IFB 298370: ADDENDUM No. 2
Amendments/Changes/ Clarification
Project: RTL Exit Phase 1 – 318 Bldg.

IFB ISSUE DATE: April 15, 2015
CLOSING DATE: May 7, 2015

ENGINEERING CHANGE NOTICE

Ductwork and venturis are required to accommodate work in Labs 131 and 148 under Phase 2 of the RTL Exit project, S720239D.

1 HVAC PLAN - LABS 131, 133
M1-101 SCALE: 1/4" = 1'-0"

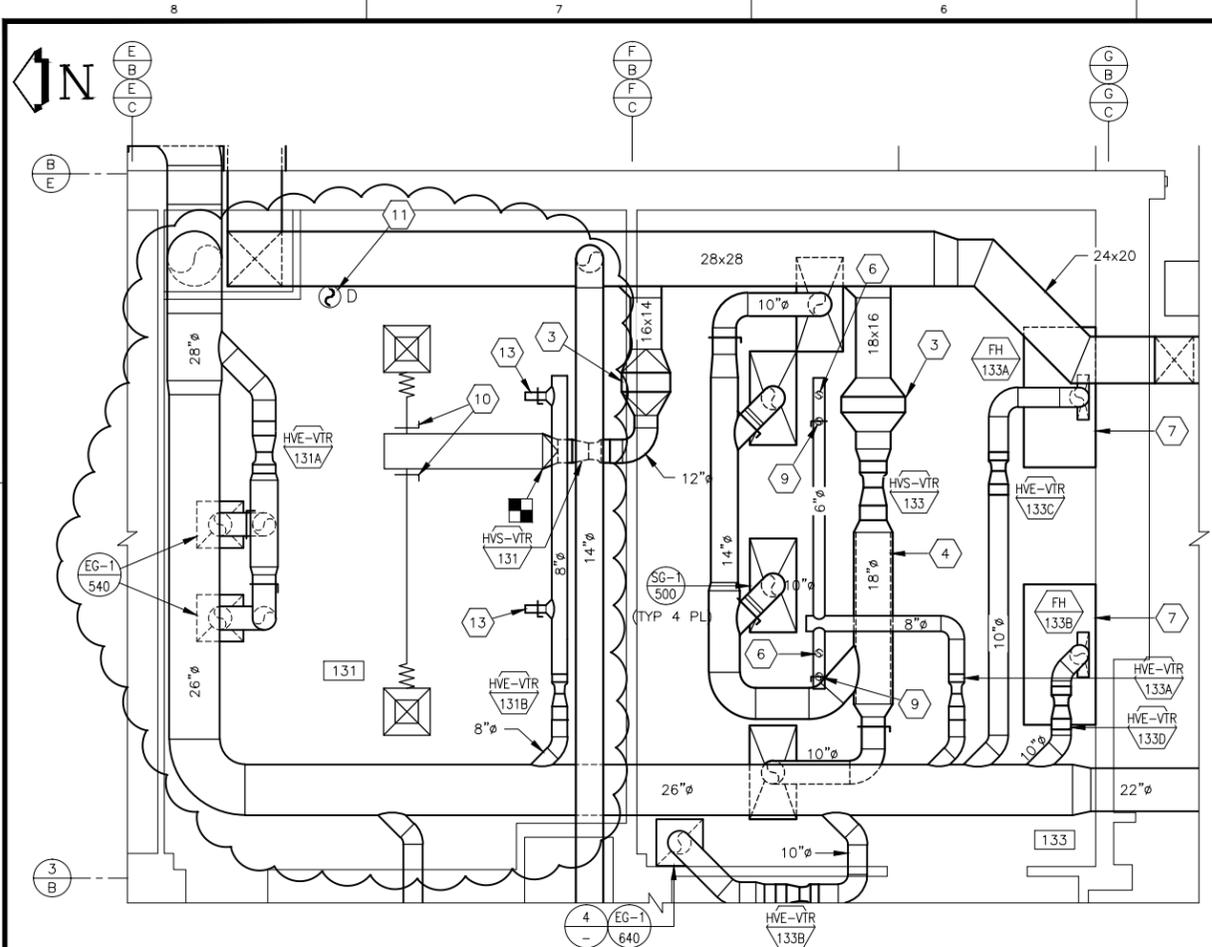
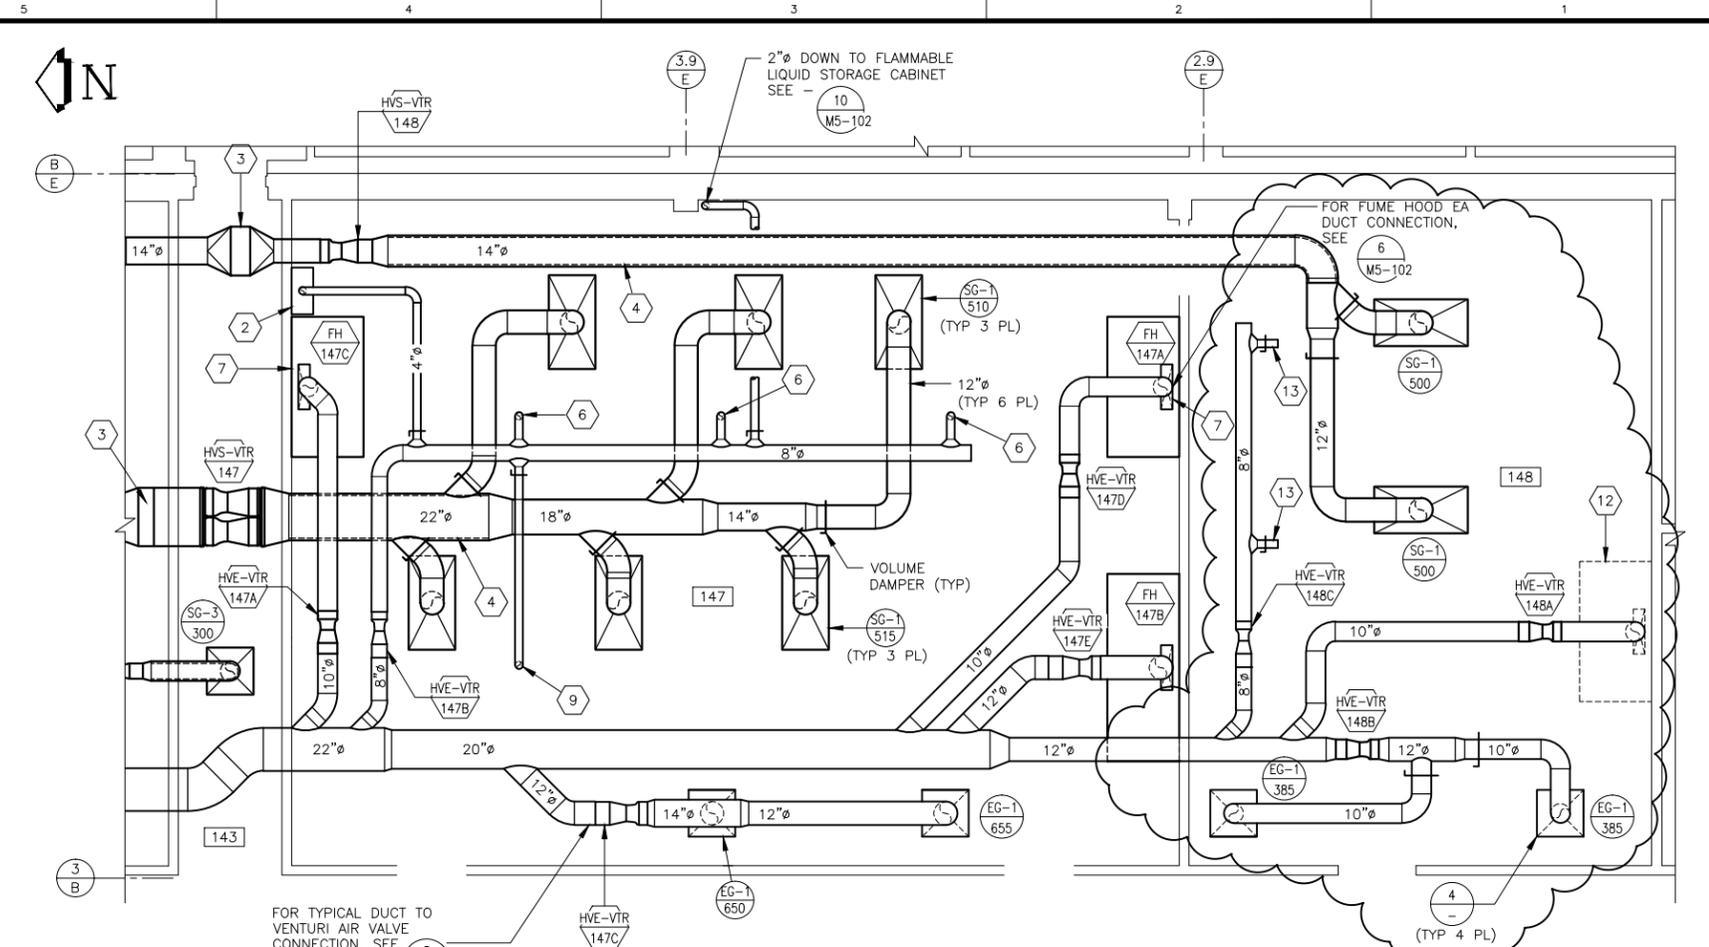
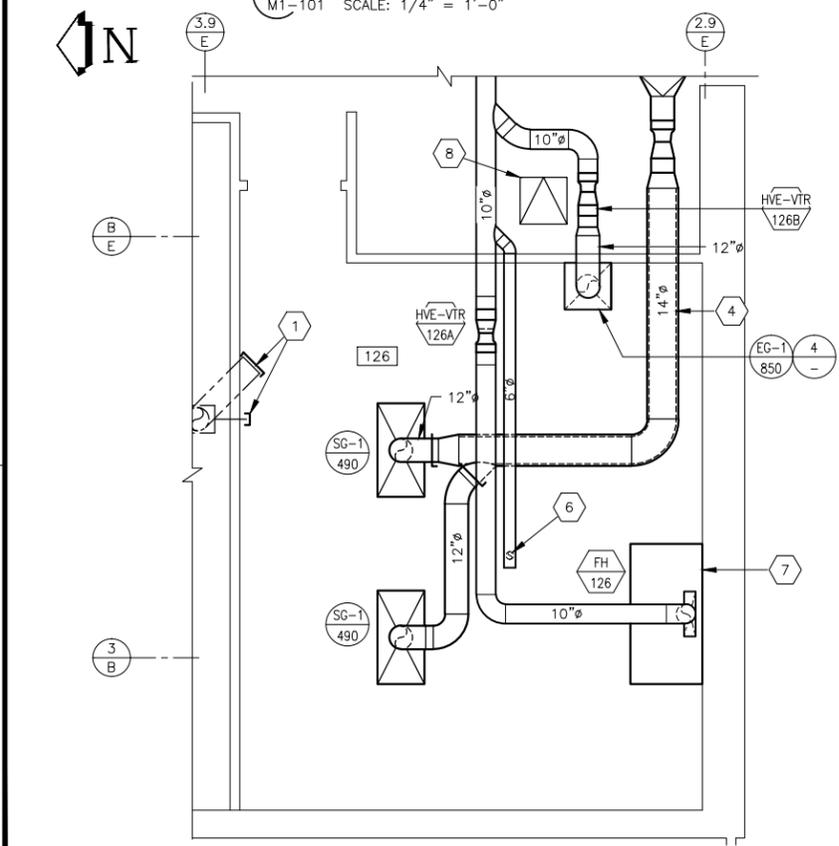
- PROVIDE 1" SOUNDLINING ON VENTURI AIR VALVE SUPPLY AIR DISCHARGE DUCT.
- 28x28 SA, 26x24 EA THROUGH WALL, FOR CONTINUATION SEE M1-101.
- 4" EA DOWN TO VACUUM POT, SEE DETAIL 7/M5-102.

- 4" EA DOWN TO SNORKEL, SEE DETAIL 4/A5-101. BALANCE TO 50 CFM.
- BALANCE EXISTING DIFFUSER TO 540 CFM.
- DUCT SMOKE DETECTOR, SEE ELECTRICAL.
- FUTURE FUME HOOD. TERMINATE 10" EXHAUST DUCT AT 8'-0" AFF.

- 4" EA FOR FUTURE SNORKEL. PROVIDE BALANCING DAMPER.
